***RE: RIO GRAND ZOO - HAY BARN (K13-D42). GRADING AND DRAINAGE PLAN
FOR BUILDING PERMIT APPROVAL. ENGINEER'S STAMP DATED
DECEMBER 12, 1997.***

RIO GRANDE ZOO

BARN ADDITION

Drainage and Grading Plan

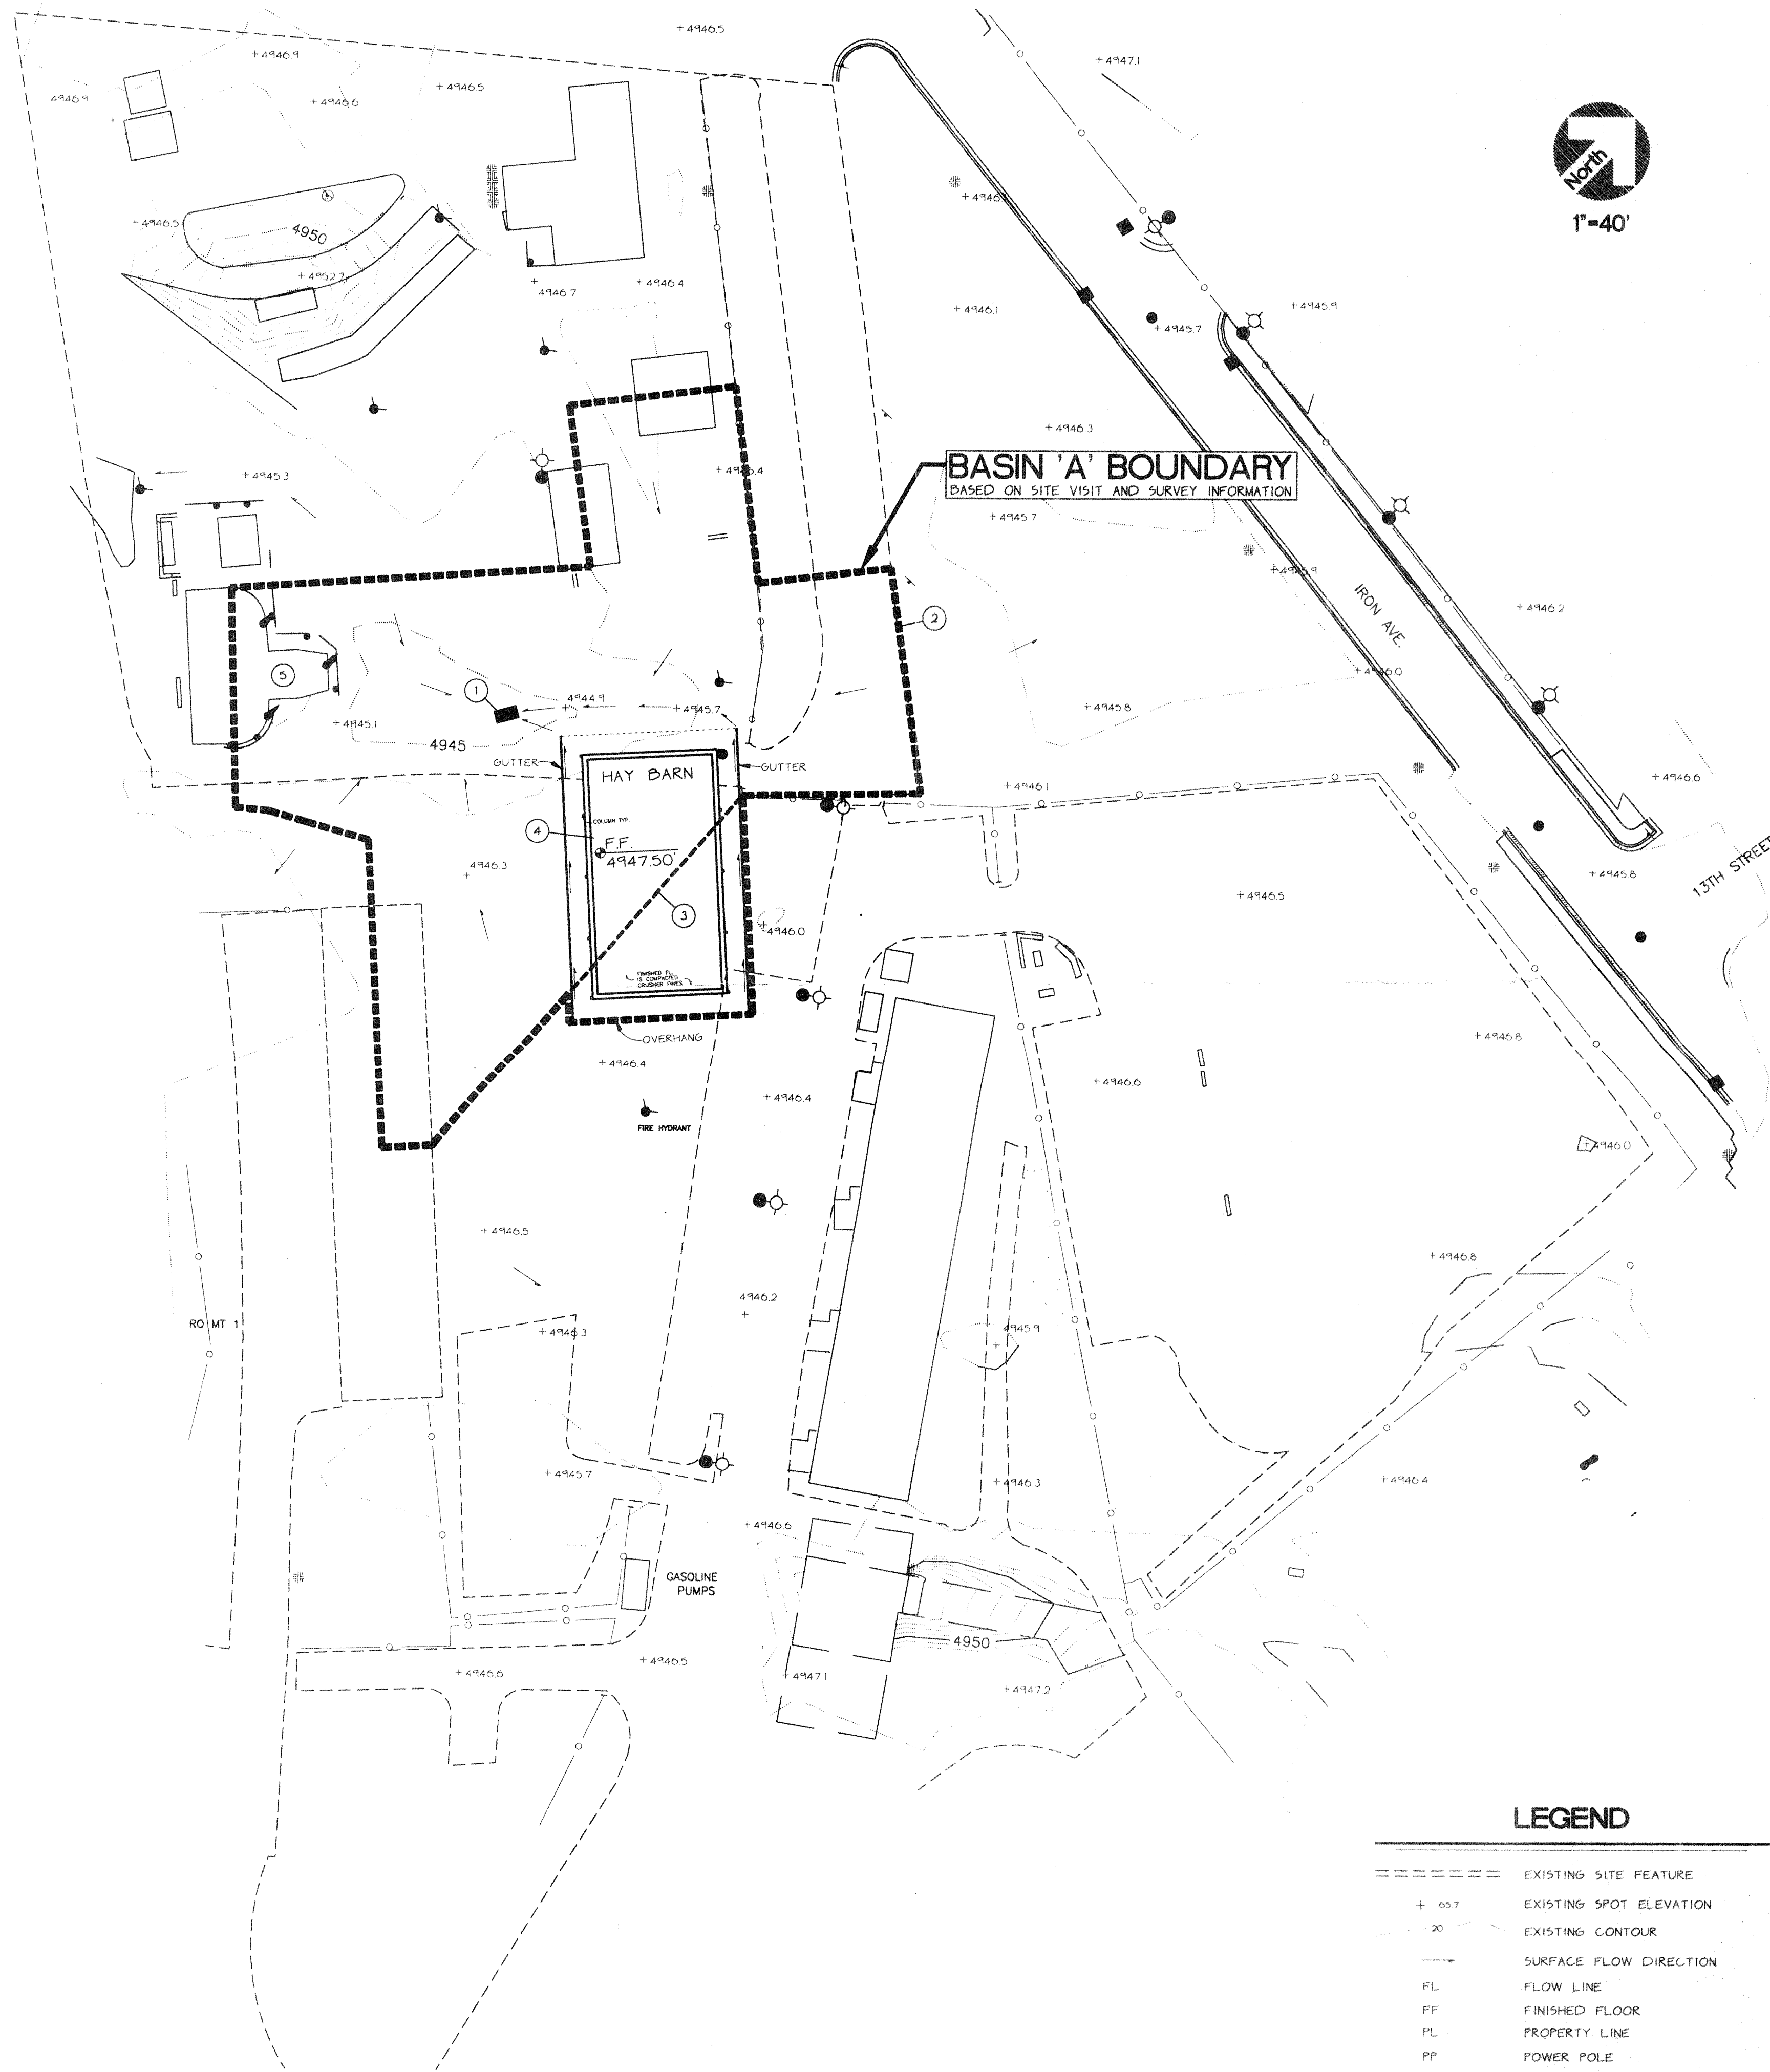
Based on the information provided on your December 3, 1997 submittal, the above referenced project is approved for Building Permit.

Prior to Certificate of Occupancy approval, and Engineer's Certification will be required.
